Ordinance No. 018020 Council Bill No. B 68-04

rezoning property located on the northwest corner of Silvey Street and West Worley Street, extended, from District R-1 to District PUD-6; approving the PUD site plan of The Villas at Vintage Falls; granting variances from the Subdivision Regulations; and fixing the time when this ordinance shall become effective.

**RE:** A request by Burton and Colette Schauf and Greenwing Development to rezone property from R-1 (One-Family Dwelling District) to PUD-6 (a planned unit development having a development density of not more than six dwelling units per acre) and for approval of a PUD site plan to be known as "The Villas at Vintage Falls." The subject property, which is approximately 39.91 acres in size, is located on the northwest corner of Silvey Street and West Worley Street, extended. The rezoning and PUD site plan would allow for construction of 86 two-family structures (172 dwelling units) on the subject site.

**ITEM NO.** 11-PUD-03

# THE VILLAS AT VINTAGE FALLS

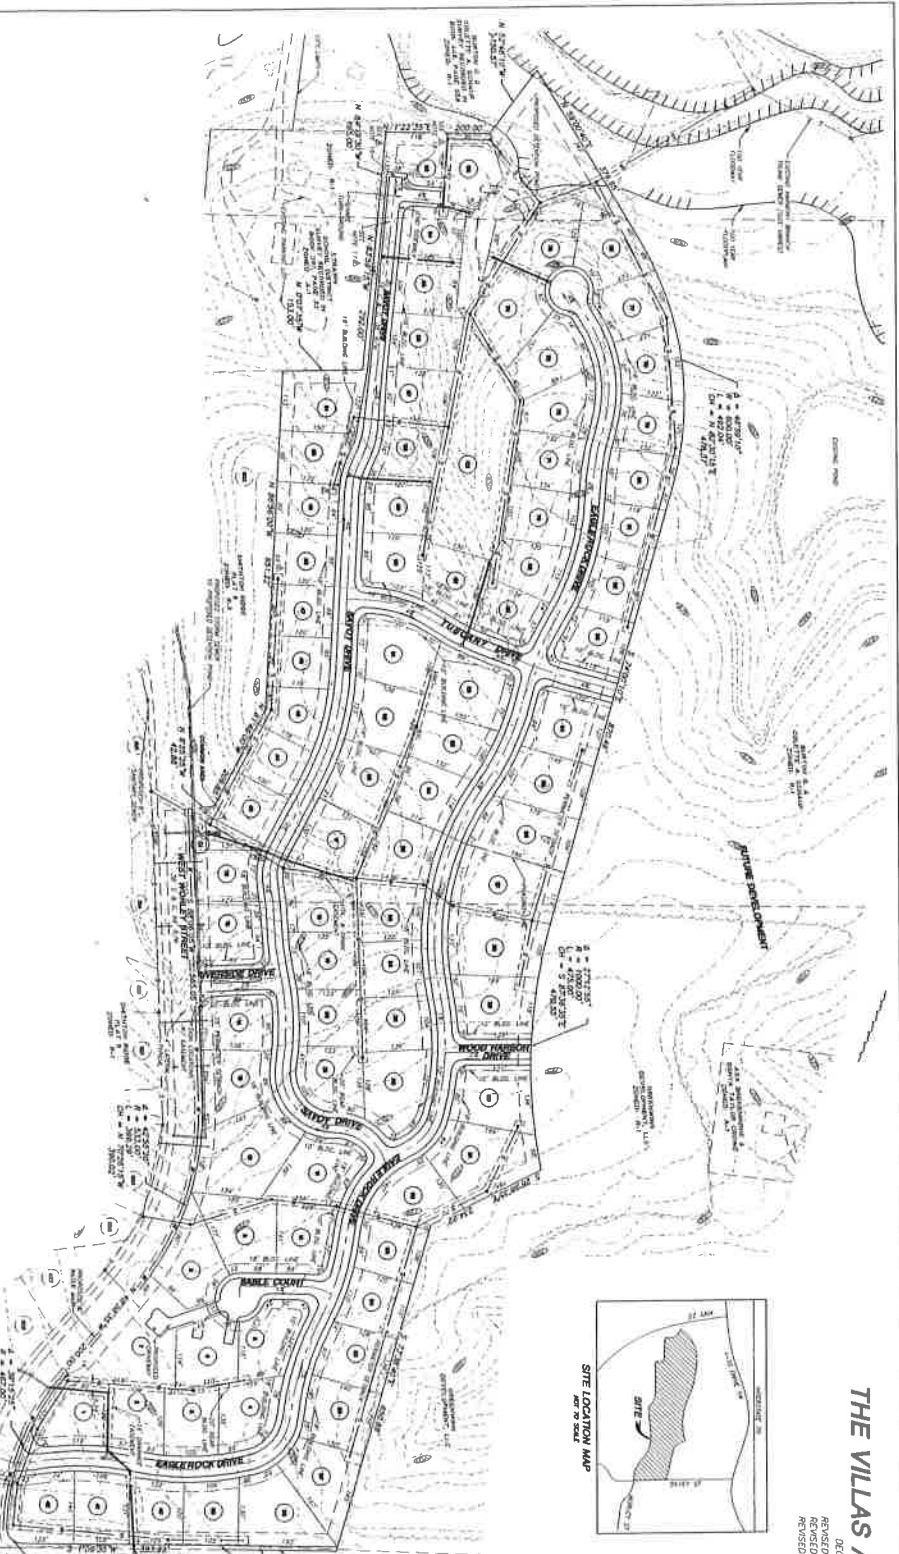
Another issue with this PUD is the proposed 18-foot building setback from internal street frontages. While there is no specific setback requirement for a PUD, other than the 25-foot perimeter setback, staff believes that 20 feet is needed to prevent long vehicles parked in the driveway from blocking the adjacent sidewalk. The applicant maintains that most of the houses will be set back a minimum of 20 feet from the street right-of-way, but the 18-foot minimum allows for some flexibility. Also, there will be restrictive covenants prohibiting parking in the driveways. The applicant has also suggested that the sidewalks could be placed closer to the street than the standard one foot from the property line, thereby allowing more room for occasional vehicles in the driveways. The Commission members felt that, under these circumstances, the 18-foot minimum was sufficient.

The first variance request is to the requirement that the internal, local residential streets be 32 feet in width (except for cul-de-sacs, which are currently allowed to be 28 feet wide). The PUD proposes that all streets, except for Savoy Drive, be 28 feet in width, within the standard 50-foot wide right-of-way. Twenty eight feet of pavement width within a 50-foot right-of-way is the new standard being proposed as part of the revised street standards; however, this revised standard is for single-family and not two-family residential development. Unless the applicant can provide some compelling reason why the streets should be less than 32 feet in width for a two-family development, staff cannot support this variance request.

The second variance request is to allow a proposed 24-foot pavement width within a 38-foot wide right-of-way for the west 400 feet (serving Lots 52-56) of Savoy Drive. The Savoy Drive right-of-way is being placed 10 feet north of the Strawn School property to allow room for a 10-foot wide utility easement on the subject site. Staff is not opposed to this "spite strip," in this case, since the applicant needs to provide room for a utility easement and the Strawn School property takes its access off Strawn Road and does not need to connect to the subject site.

The third variance request is to allow a "t" type turn-around at the terminus of Savoy Drive, in lieu of the standard cul-de-sac bulb of 94 feet of right of way and 76 feet of pavement. The proposed "Access" street would require a cul-de-sac bulb but with a reduced diameter of 84 feet of right of way and 68 feet of pavement. The "T" would be adequate for cars and light trucks but may present a problem for large vehicles such as trash trucks. The Public Works Department has identified operational problems with the "t" turn around. It may act as a vehicle storage area, which would block street sweepers and refuse vehicles. It could also create a problem with accumulated debris, if the street sweeper cannot adequately clean the turn around area. Staff is also concerned that this will set a precedent for future PUDs. In other words, if this is approved, it may become "the new standard" for cul-de-sac design on future PUDs.

The 28-foot wide streets, the lack of parking for Savoy Drive and "t" type turn around variances are problematic to staff. In addition to the street issues, staff is of the opinion that the 18-foot front setback proposed for the residential dwellings is too shallow and should be increased to 20 feet. This is due to the fact that some vehicles, such as trucks, vans and large SUVs are over 17 feet in length and, when parked in a driveway in front of the garage, they will extend out over the sidewalk if the setback is only 18 feet. Drivers cannot be expected to park their car with the bumper right up to the garage door.

Staff would recommend approval of a revised PUD site plan, which eliminates the above problems. Staff suggests that the site plan be tabled to March 4, 2004, to allow time for revisions to be made. If the applicant is unwilling to revise the plan, staff recommends denial.

1. That a payment of \$14,742 toward future improvements to Silvey Street be paid prior to final plat approval
2. That the plan be revised to allow for parking on one side of Savoy Drive.
3. That at the time of final plat submittal, the final plat shall show a greenspace trail easement along the Harmony Creek 100-year flood plain; and, that the final plat show a minimum 10-foot wide pedestrian easement, connecting at least one of the public streets within the development to the greenspace trail easement.
